From: [REDACTED]
Sent: Thursday, August 6, 2026 6:05 PM
To: Tabor, Mekdes
Cc: [REDACTED]
Subject: Prince William Parkway and Clover Hill Road Interchange Public Information Meeting Comments

Clover Hill DDI Interchange and Roundabout Thoughts

Re: Proposed Design for the Prince William Parkway and Clover Hill Road Interchange Project

Alternate Configuration 1: Squished Single Roundabout

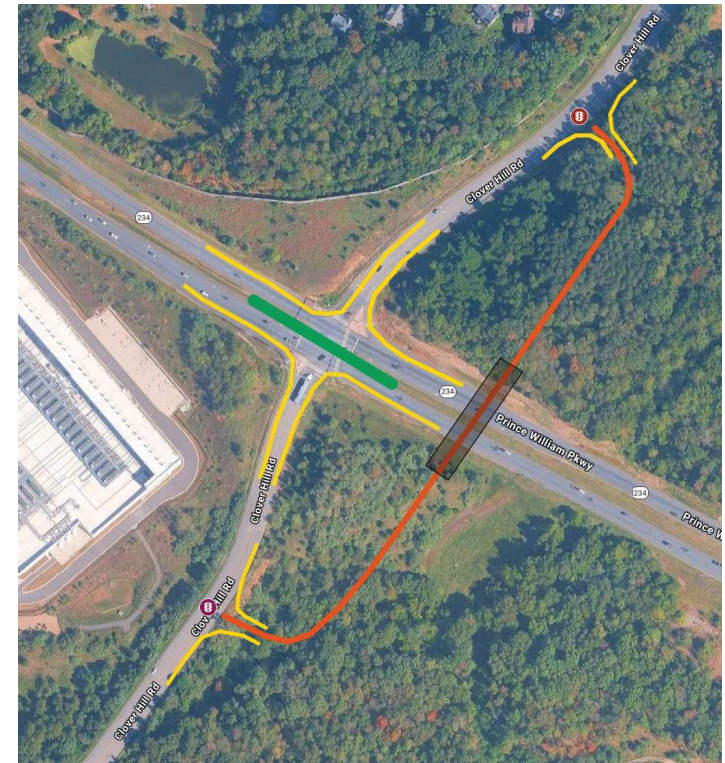
- Safety benefit from single roundabout, footprint of double roundabout
- Does not require queuing space on bridge like double roundabout, permits wider spacing with Godwin roundabout
- No traffic lights = lower operational cost of interchange

- Crosswalks are not signal-controlled, rely on traffic calming effect of roundabout design to provide pedestrian safety at point of interaction (consider raised crosswalks to further reduce vehicle speed)

Top: Squished single roundabout interchange in Carmel, IN.

Left: Augmented squished single roundabout interchange by Vienna metro station.

CHR design would likely be closer in scale and modal share to Carmel example

Alternate Configuration 2: Offset ParClo-AB

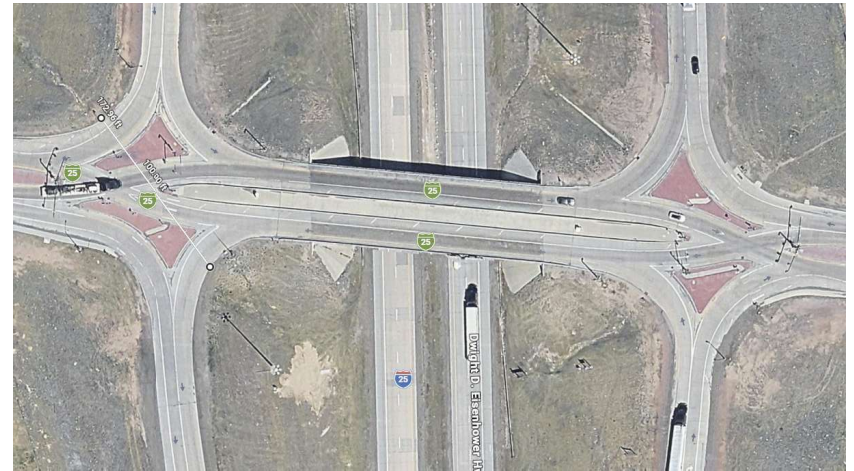
- Right-turn lanes/ramps on existing pavement present obstacle for planned 234 SUP, designs with new ramps offer more clear opportunity for eliminating this obstacle in advance with minimum additional disruption/cost
- Wider interchange footprint risks queuing interference with Godwin roundabout
- AB ParClo layout has more crossing conflicts than the VJuST assumed layout: +8 to weighted conflict points, equivalent to traditional diamond

AB ParClo overlaid on project area. Replacing traffic lights w/ roundabouts takes this from 28 weighted CP to 16, replicating a double roundabout from a safety perspective

FIGURE 3-23 DOUBLE LEFT TURN LANES*

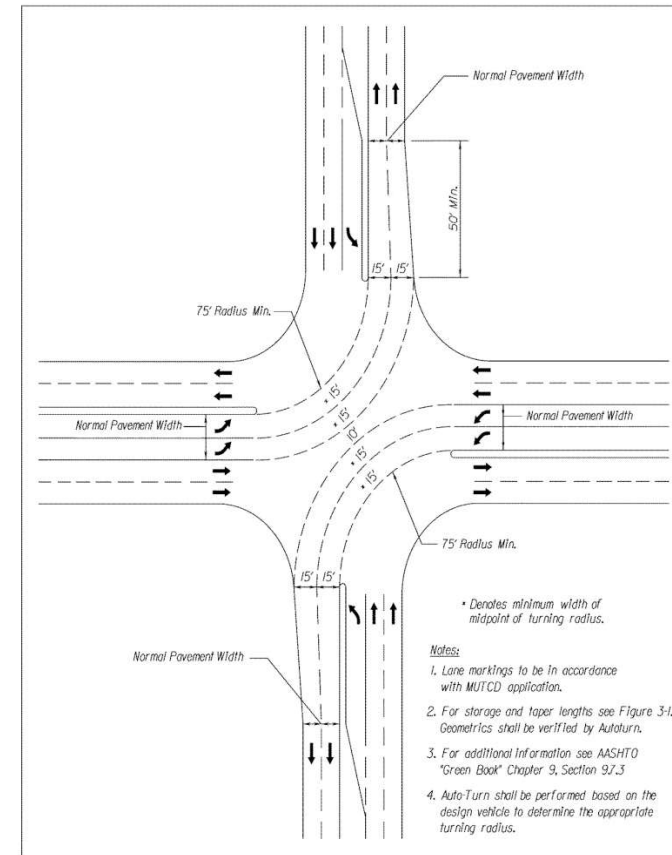
- 15' lanes are above normal lane design spec but justified by project personnel referencing VDOT design standard for 15' approaches on DDI. VDOT design standard in question is found on page A3-40 of the VDOT RDM and references Figure 3-23 in Appendix F (depicted here).
- The Balls Ford Road DDI uses 12' bridge lanes.

Design Consideration 3: 234 SUP

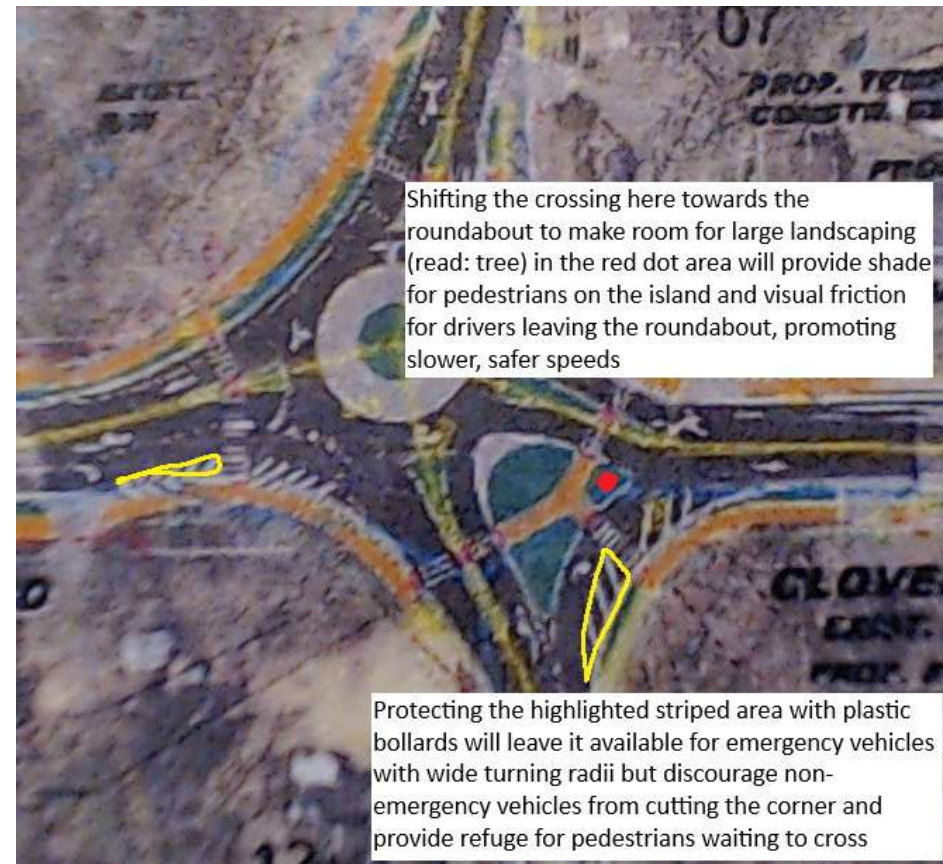
- Providing connections between the outside of the interchange and the space allocated under the bridge for the 234 SUP will be easiest/most cost effective/least disruptive while the new highway ramps are being constructed.
- Recommend installing a box culvert under the east-side ramps during earthworks/grading to provide an easy connection for future path construction efforts

Blue boxes represent possible box culvert sites to provide connectivity to the underpass before doing so would disrupt traffic and cost big bucks

Adjacent Traffic Calming Opportunities

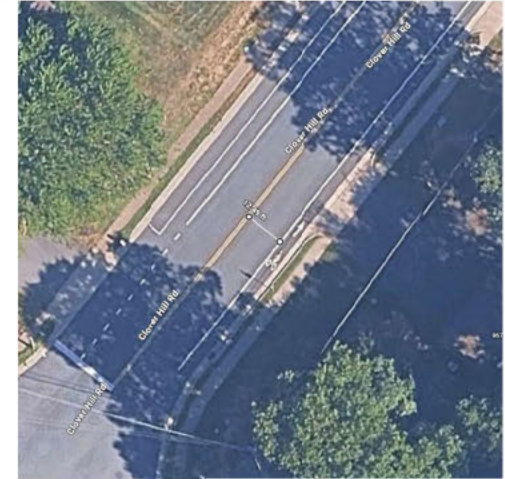
- The car lanes on CHR adjacent to the project area are 12.5' wide, 2.5' wider than the Manassas MMP recommended width for neighborhood connector streets and 3' wider than its narrowest point on the approach to Hastings Drive intersection. Reclaiming 2-3' of space on each side of the roadway to provide a buffer (painted or physical) for the bike lanes here will encourage legal and safer speeds on this road. Particularly useful on the north side where parked cars present additional risk to cyclists
- The car lanes on Godwin north of the project area are also 12.5 feet and include a painted median up to 12.5 feet in width. Reclaiming that space could allow for the unprotected bike lanes that terminate at Winged Elm Circle to connect to the project SUP and encourage legal and safer speeds on this road
